Product Change Notification

Product Group: TC/Thu Apr 4, 2024/PCN-TC-001-2024-REV-0

Laser Marking of Wet tantalum capacitors, Axial through-hole terminations.

SUBJECT: PCN-TC-001-2024 Laser Marking Addendum

LASER MARKING EXAMPLES

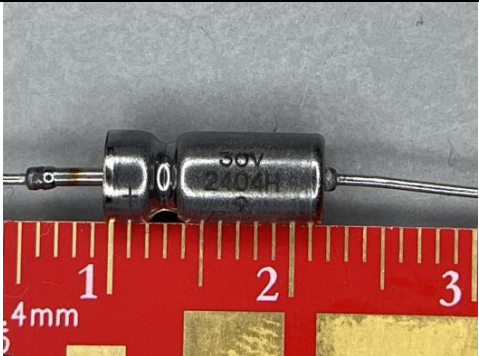
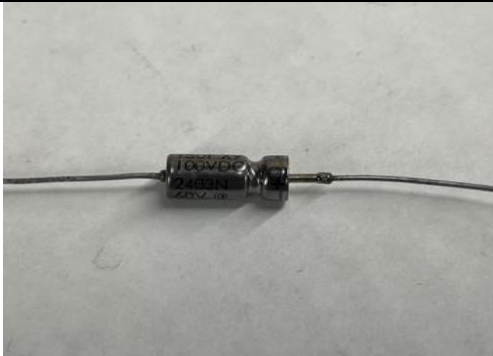
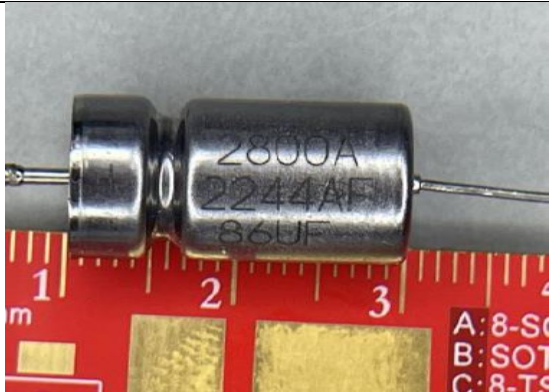
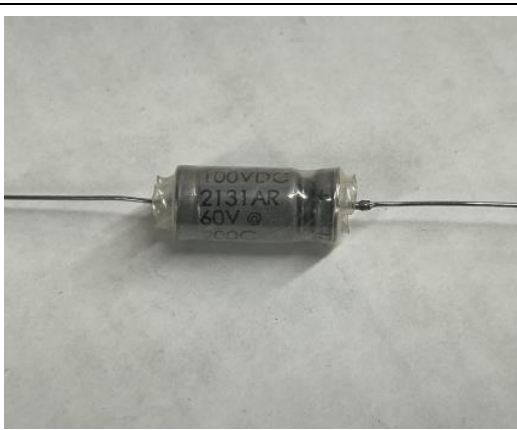
Description of Change: New system being installed which will allow laser marking of the axial capacitors.

Reason for Change: Simplify and more efficiently mark axial leaded capacitors.

Expected Influence on Quality/Reliability/Performance: There is no impact on quality, reliability or performance. Quality of laser marking is better and more repeatable quality.
